MONROE COUNTY PLAN REVIEW COMMITTEE

**January 14, 2021
5:30 pm**

CASE NUMBER	2012-PUO-05
PLANNER	Anne Crecelius
PETITIONER	Van Buren Township Trustee c/o Chris Cockerham
REQUEST	Fieldstone Outline Plan Amendment Three (Parcel L)
ADDRESS	W State Road 48 Parcel #: 53-09-02-200-001.001-015
ACRES	4.49 +/-
ZONE	PUD Fieldstone
TOWNSHIP	Van Buren
SECTION	2
PLATS	Unplatted
COMP PLAN	MCUA Phase I: Suburban Residential
DESIGNATION	MCUA Phase 2: Gateway West (G1)

CASE NUMBER 2012-PUO-06
PLANNER Rebecca Payne
PETITIONER White Oak Endeavors, LLC
c/o Daniel Butler, Bynum Fanyo & Associates, Inc.
Michael Carmin, Carmin Parker, PC
REQUEST White Oak - Planned Unit Development Outline Plan
ADDRESS 4691 S Victor Pike
ACRES 44.07 +/-
ZONE RE1
TOWNSHIP Perry
SECTION 20
PLATS Unplatted
COMP PLAN MCUA Mixed Residential
DESIGNATION

EXHIBIT 4: Petitioner Site Plan – Parcel L

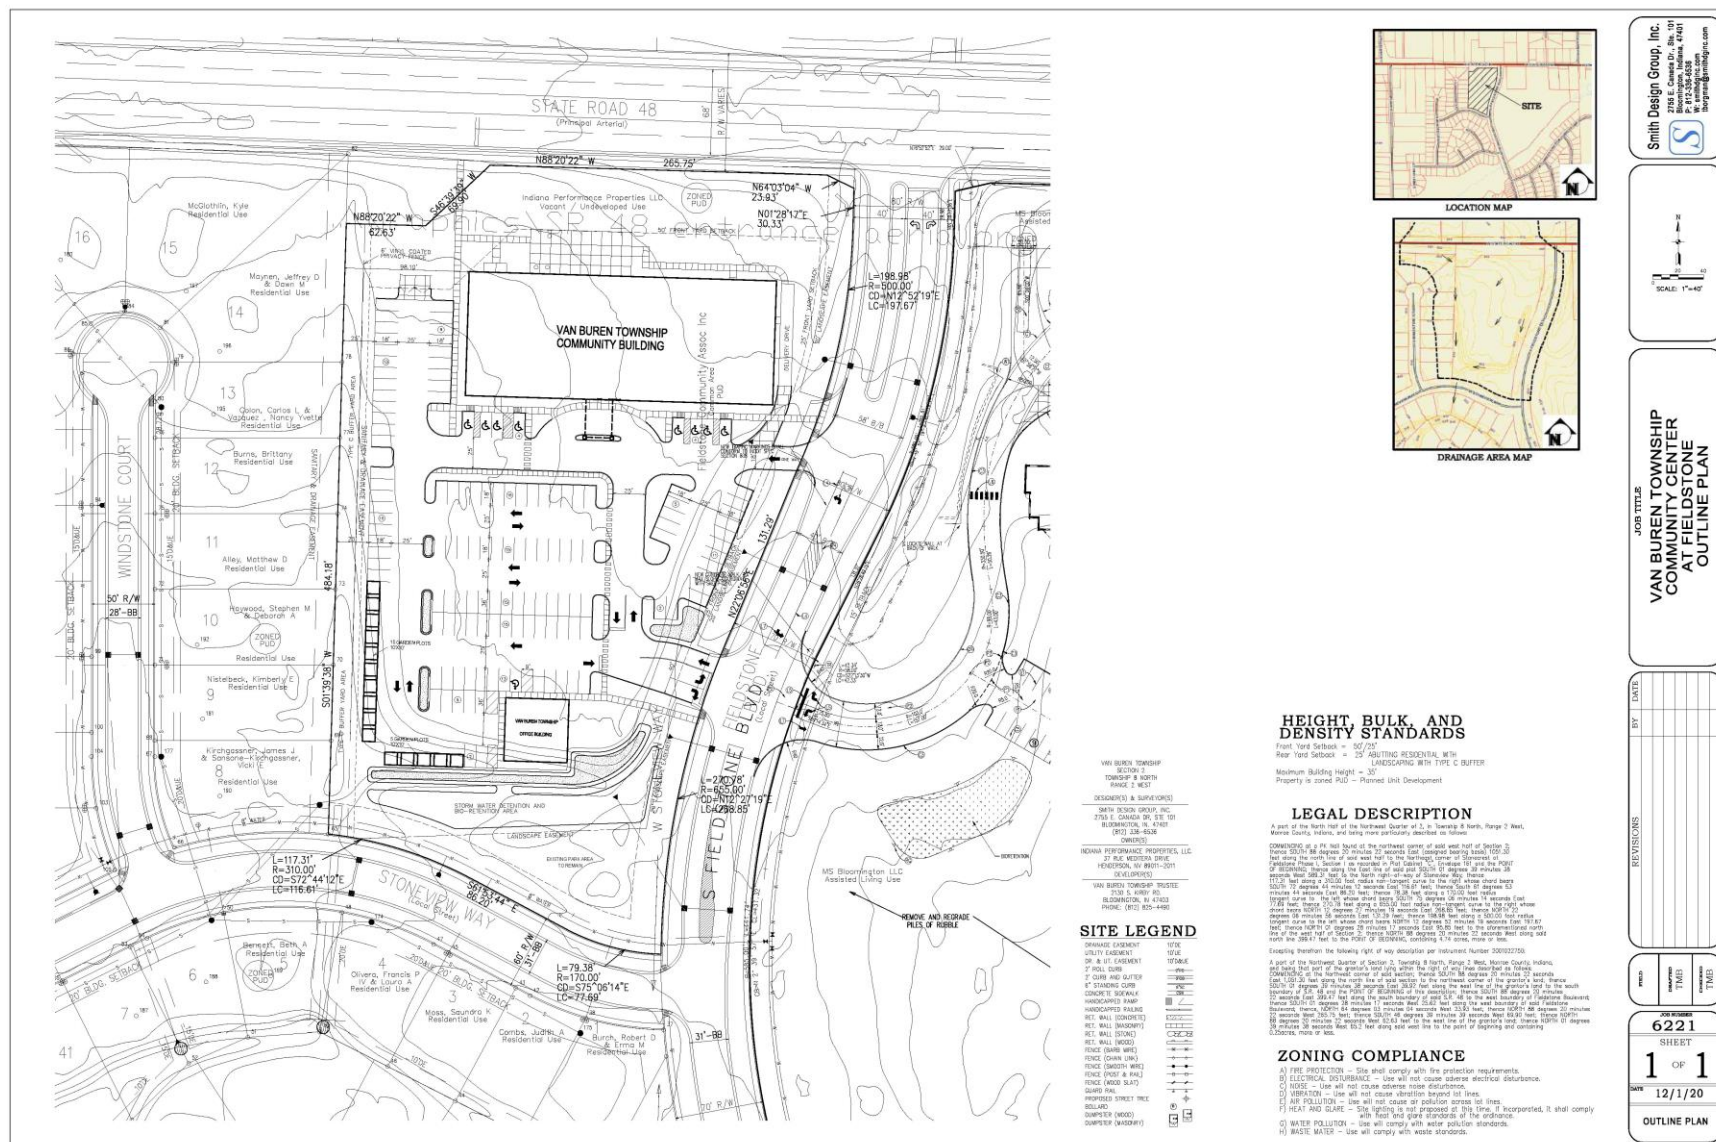
The petitioner submitted a Use Determination form to identify the correct uses. The Planning Director, Larry Wilson, stated that the use “Agricultural Uses, Non-Animal Related” use should be limited to a “community garden/greenhouse”. Exhibit 4 is an illustrative site plan drawing to show the proposed development of the site. The petitioner is also seeking to clarify development standards for Parcel L, specifying bulk, open space, and setback standards. They have also proposed reduced bufferyard landscaping requirements.

- Front yard Building / Parking (SR 48) = 50’ from the R/W line
- Front yard Building / Parking (Fieldstone Blvd.) = 25’ from the R/W line
- Front yard Building / Parking (Stoneview Way) = 25’ min from the R/W line or existing landscape easement width, whichever is greater
- Side yard Building / Parking (adjacent to residential) = 25’ Additional Side Yard Setback for each
- Additional Story = 0’ Type C

EXHIBIT 5: Fieldstone PUD Outline Plan Map

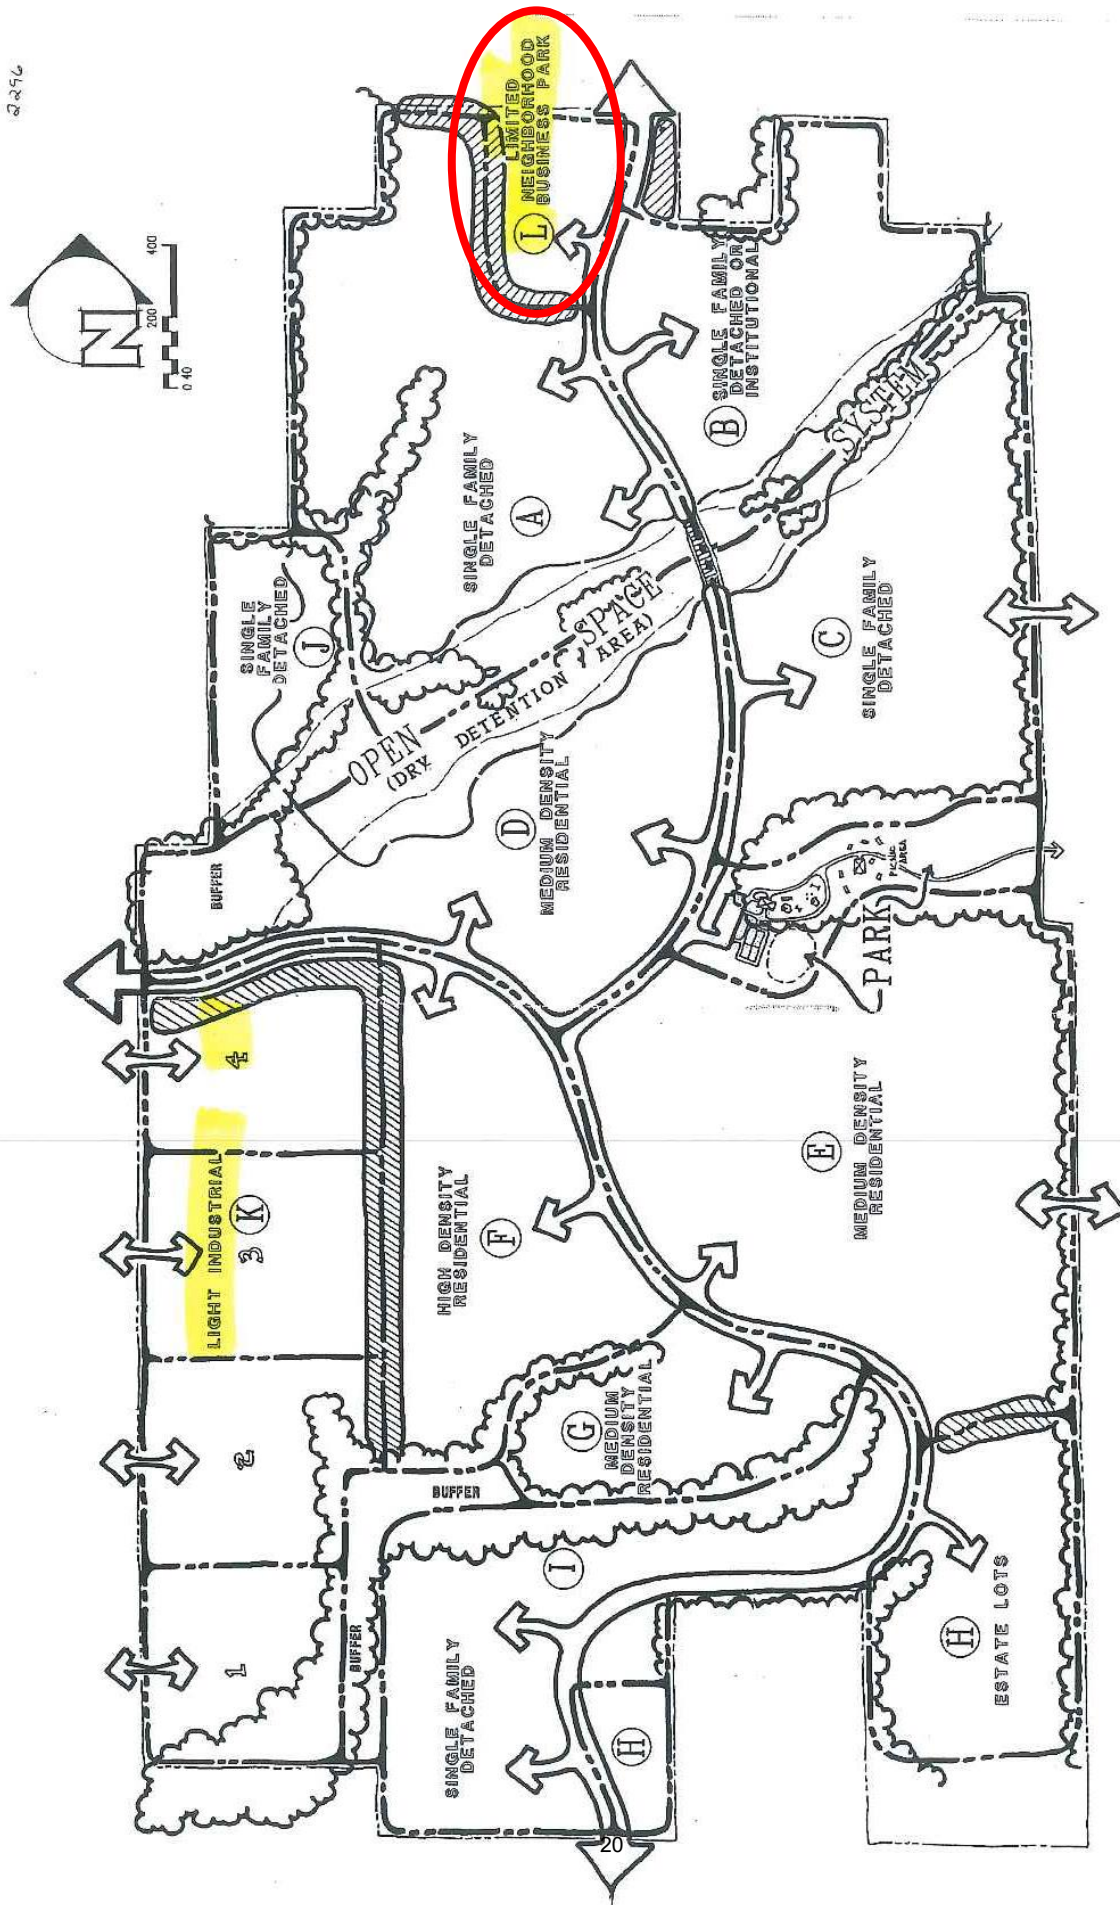
“Parcel L” is zoned as a Planned Unit Development (PUD) and is part of the Fieldstone PUD. The parcel is undeveloped and vacant. The PUD designated Parcel L as Limited Neighborhood Business Park. Exhibit 5 illustrates the PUD from the original PUD Outline Plan Map. The adjacent uses are an Assisted Living/Skilled Nursing Facility and single-family residential.
